ADDENDUM #1

- A. Project Number: 2018-10259
- B. Project Title: Spokane Falls Station
- C. Project Location: Spokane Falls Community College
3410 W. Fort George Wright Dr., Spokane, WA
- D. Agency: Spokane Transit Authority

DATE	DRAWN	DWG. NO.	JOB NO.	REF. SHT.
2/15/19	BLW	CC-01	2018-10259	2/6

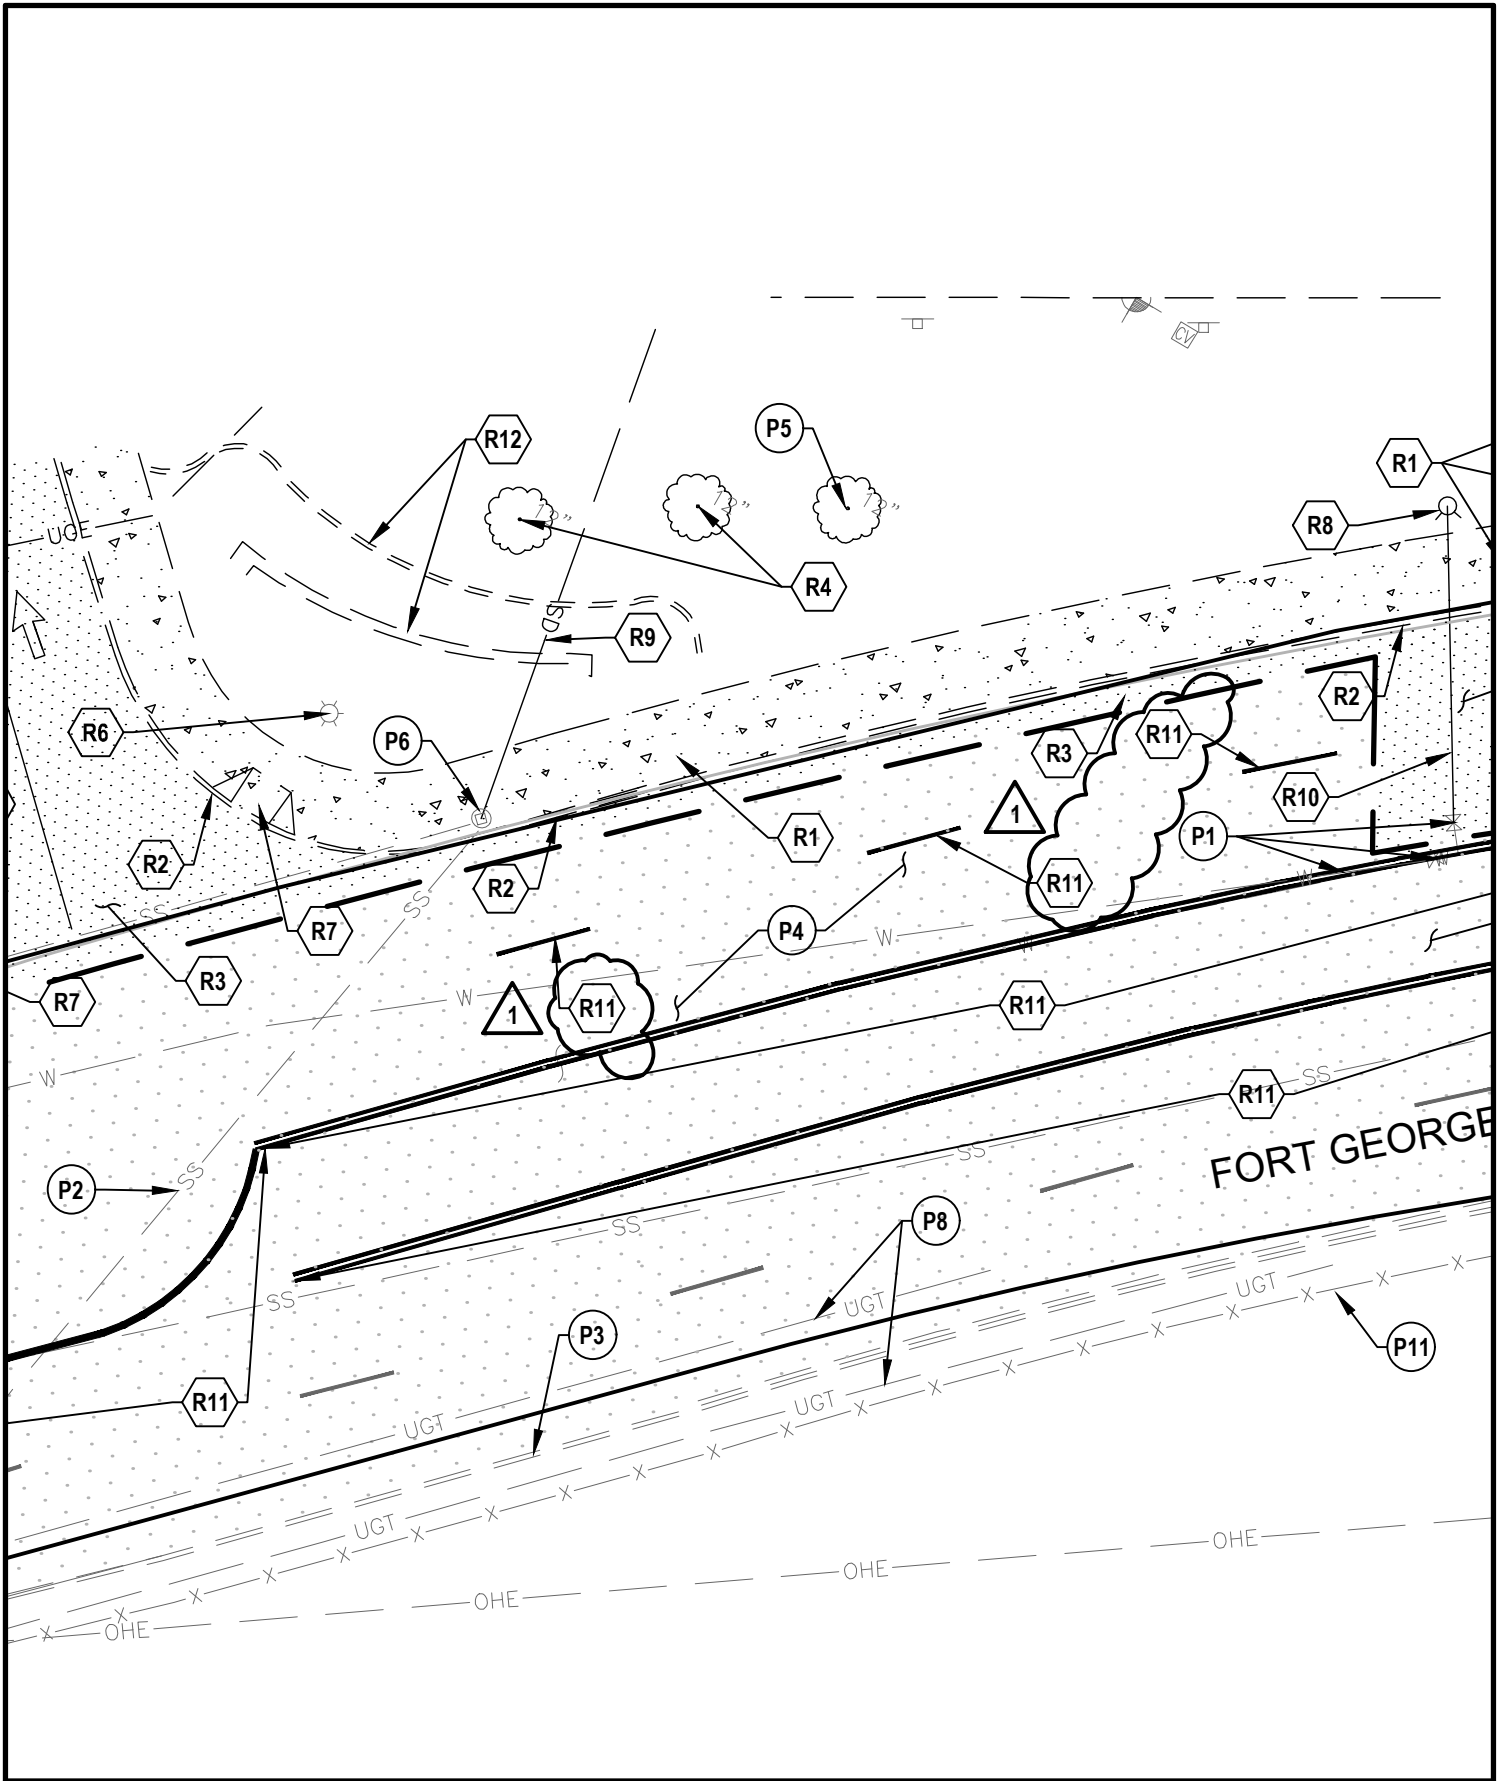
Revised striping at east entrance on Fort George Wright. Switched "DOTTED WIDE LINE" for "SKIP LINE" on Note D. See attached DWG NO. CC-01

DESCRIPTION
STRIPING UPDATES AT EAST ENTRANCE

<p>SPOKANE FALLS STATION 2018-10259</p>	 <p>10 N. Pine Street, Suite 500 Spokane, WA 99201 ph 509.328.5994 fax 509.328.2999 coffman.com LASTING quality locally relationships</p>	ADDENDUM # 1			
		DATE 2/15/19	DRAWN BLW	DWG. NO. CC-02	JOB NO. 2018-10259
DESCRIPTION REMOVE ADDITIONAL STRIPING

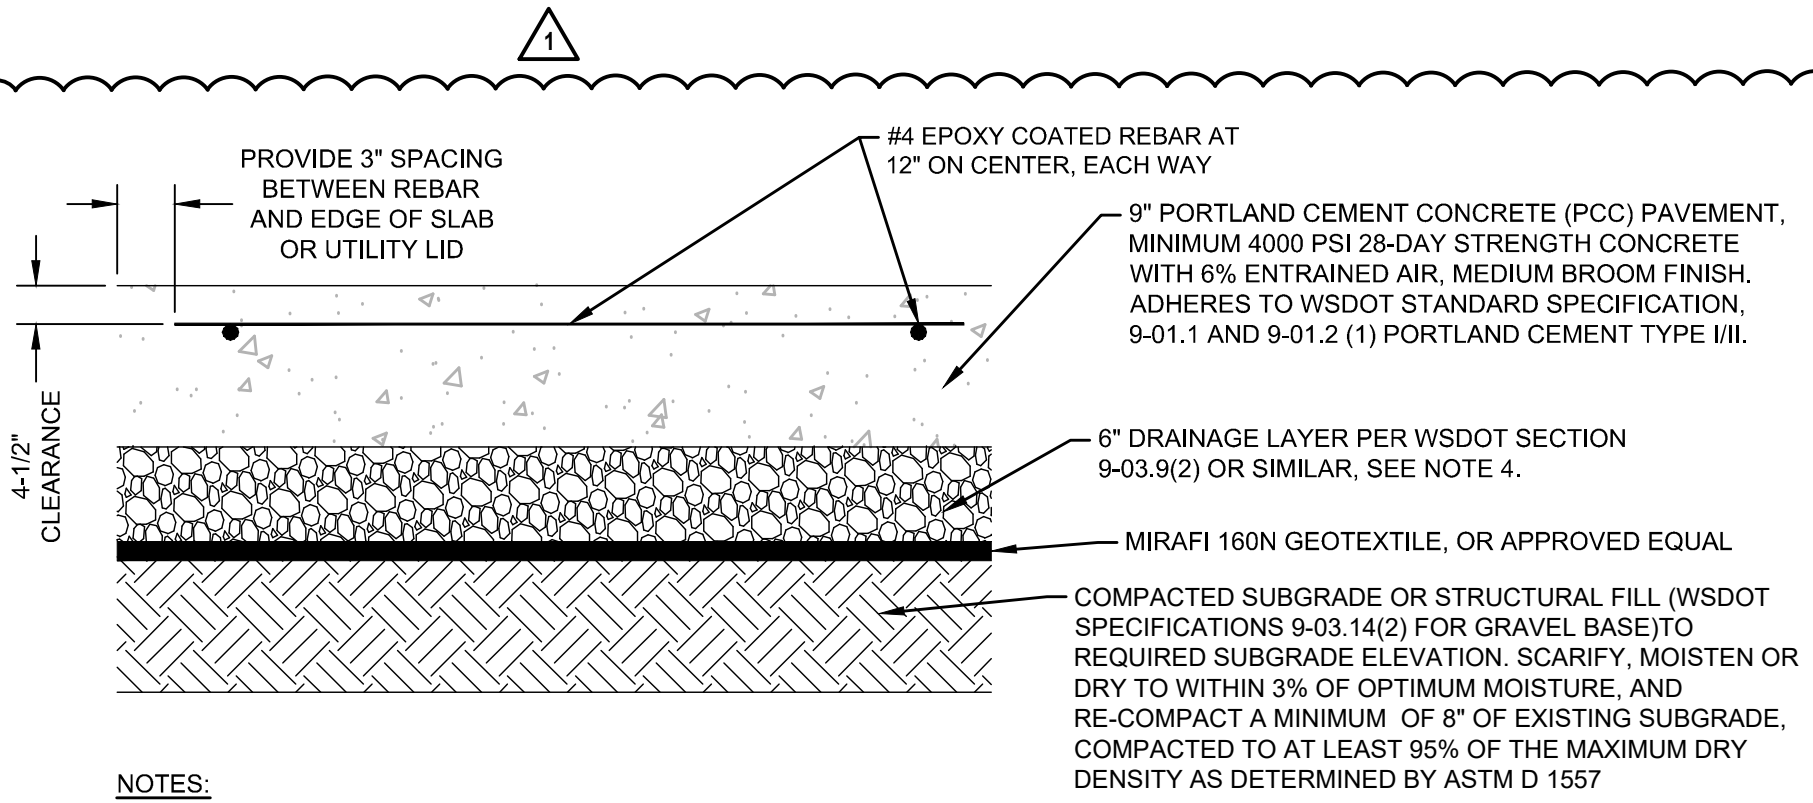
Add additional remove striping callouts. See attached DWG NO. CC-02.

DATE	DRAWN	DWG. NO.	JOB NO.	REF. SHT.
2/15/19	BLW	CC-04	2018-10259	3/6
DESCRIPTION ADDED CONCRETE APPROACHES

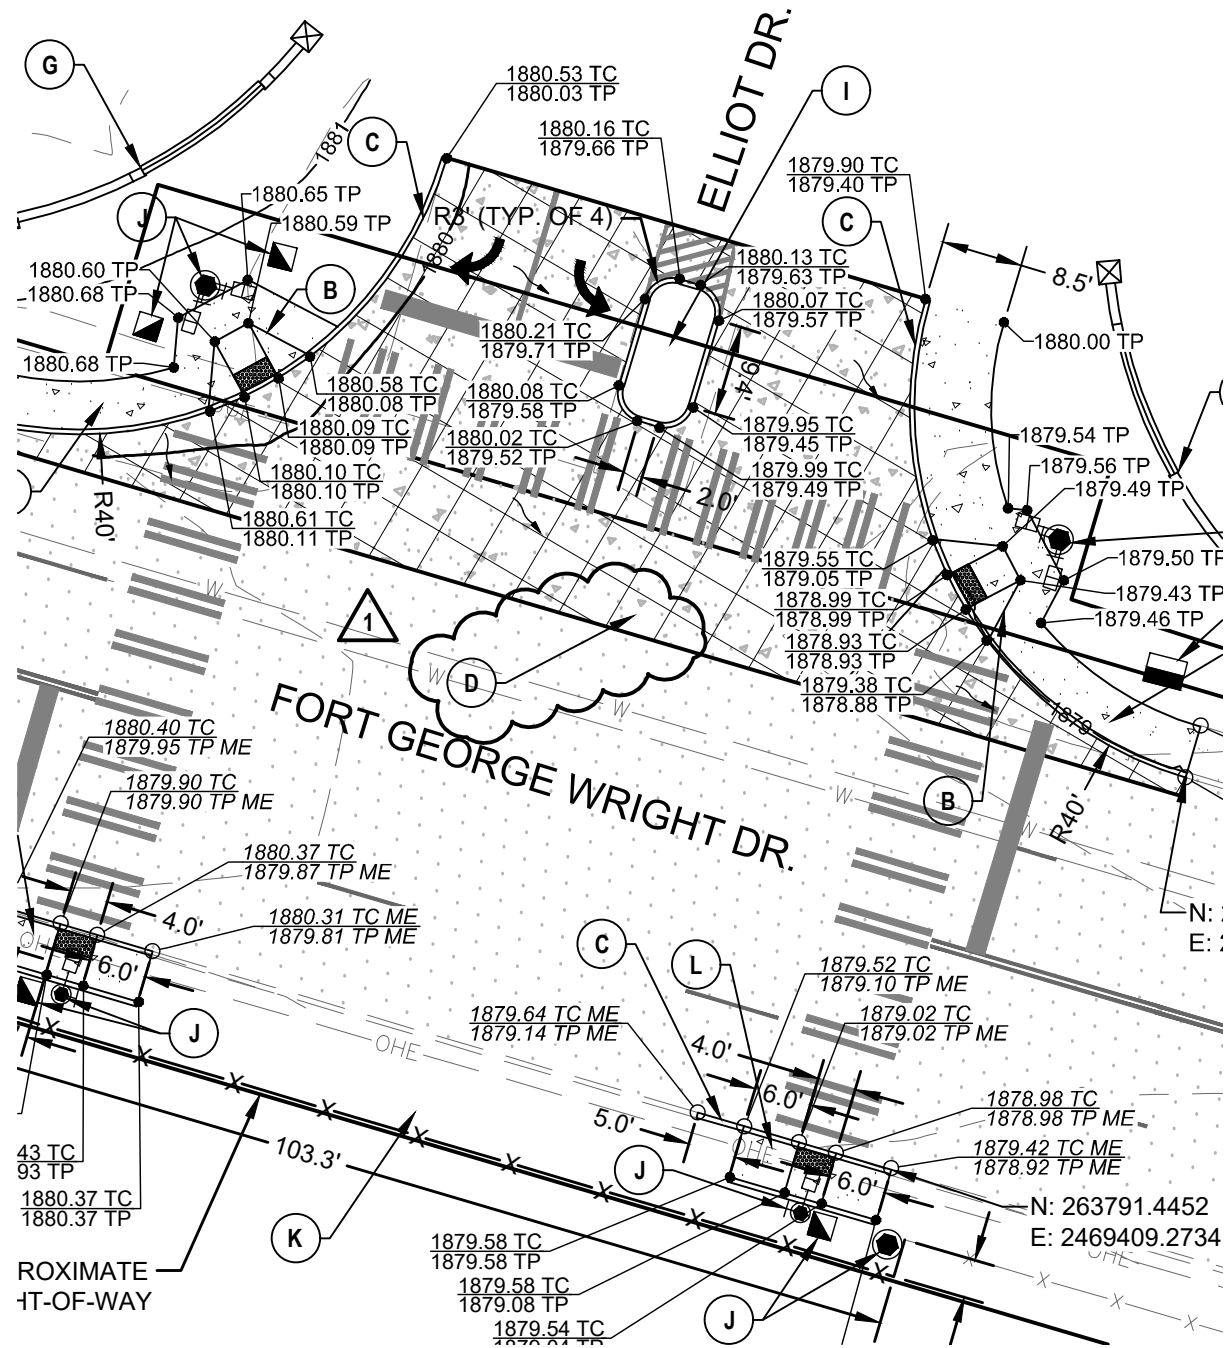
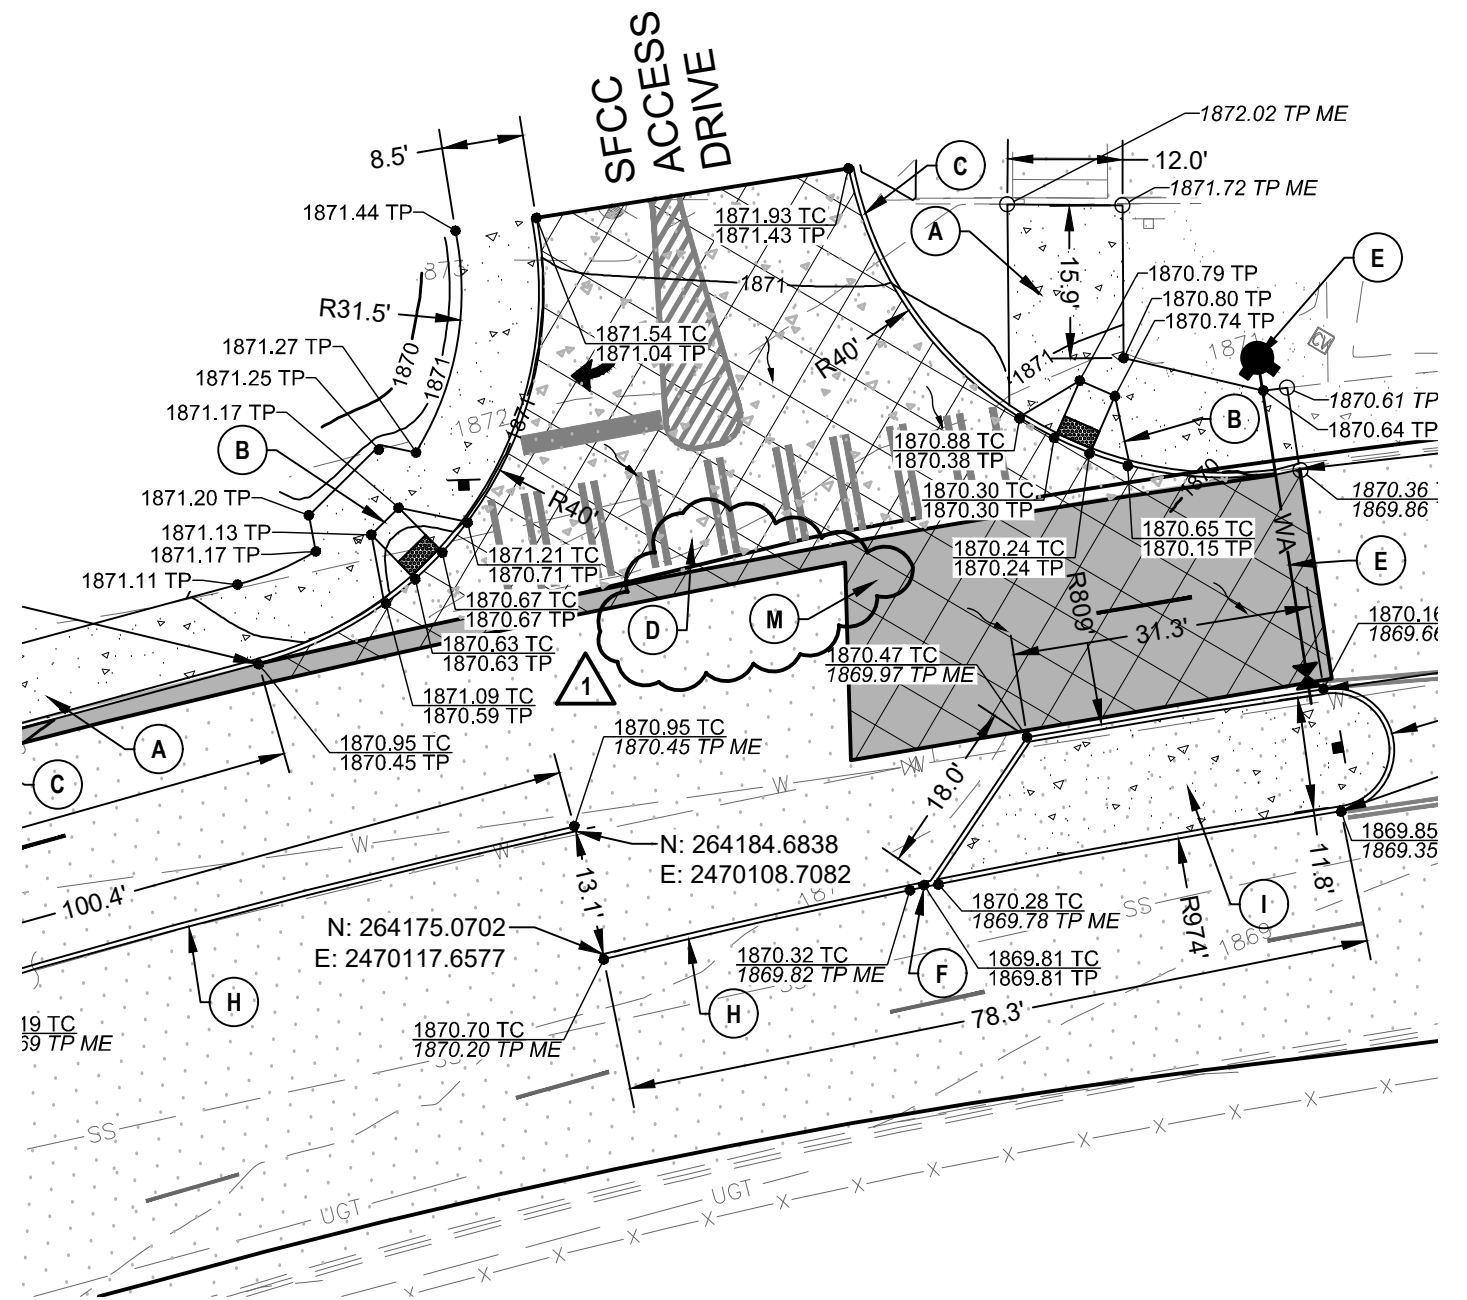
Revised east and west entrance on Fort George Wright to be concrete pavement instead of heavy-duty asphalt. Replaced detail 1 with a concrete pavement detail. Added note for contractor to match existing asphalt section for portion of Fort George Wright that will be replaced. See attached DWG NO. CC-03 and CC-04.

ADDENDUM # 1			
		DATE 2/15/19	DRAWN BLW	DWG. NO. CC-05	JOB NO. 2018-10259
SPOKANE FALLS STATION 2018-10259		DESCRIPTION REMOVED EXISTING DRYWELL FROM SWALE #4

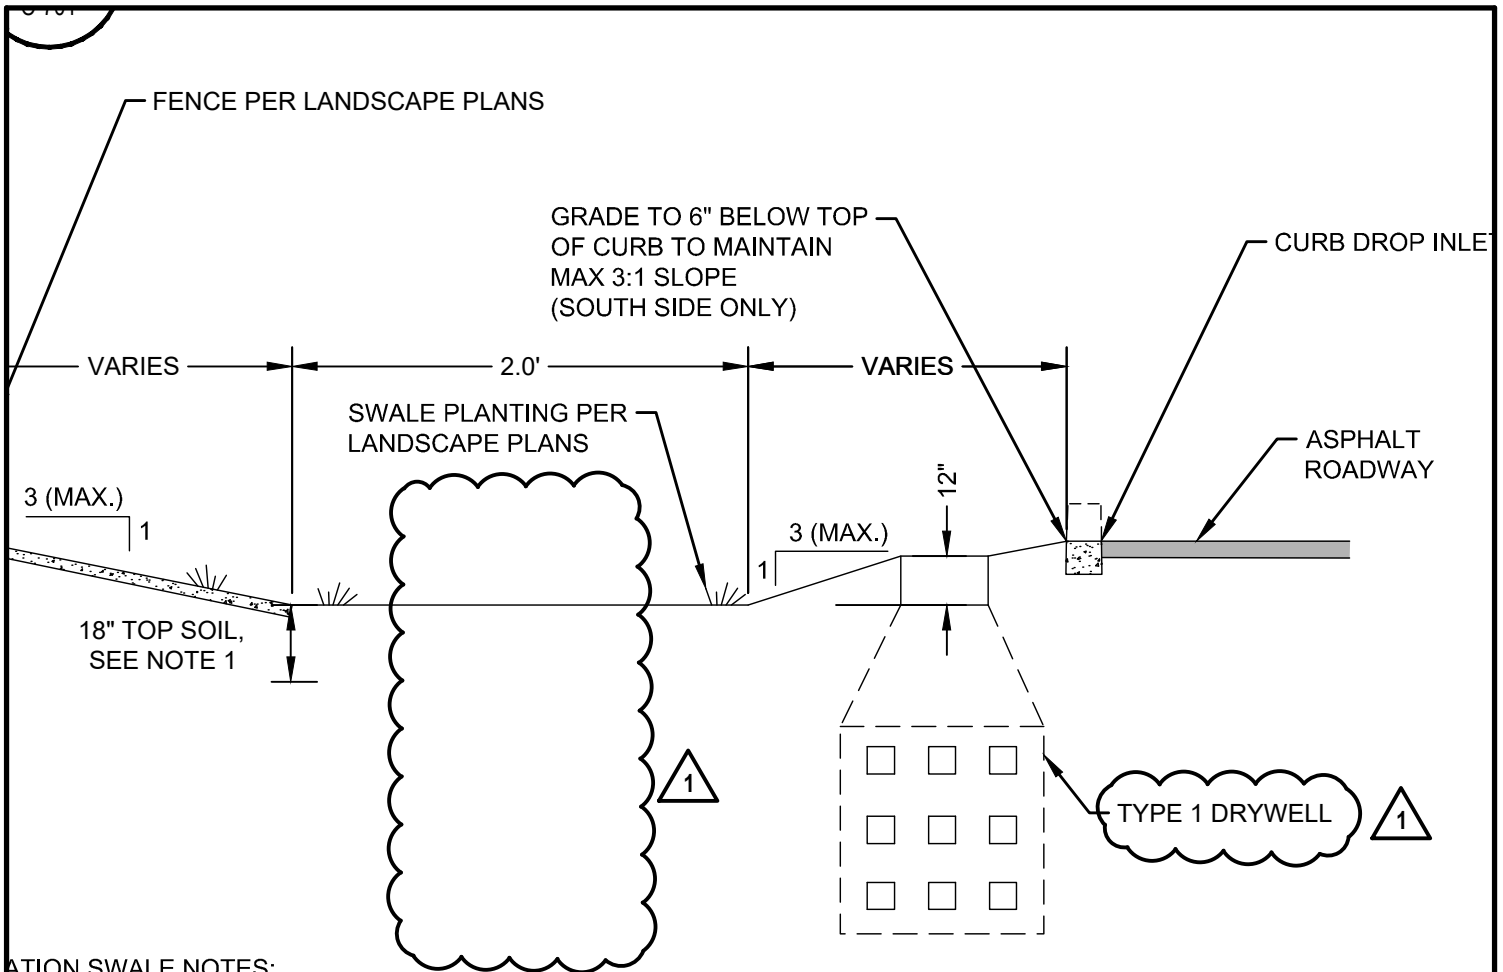
- K. **Sheet C-802 –**
Revised detail 10 to show one proposed type 1 drywell. See attached DWG NO. CC-05.
 - L. **Sheet L-200 through L-203 –**
Update Plant Schedule to include reference to City standard planting details. Update General Planting Notes with City standard notes. See attached DWG NO. CL-01.
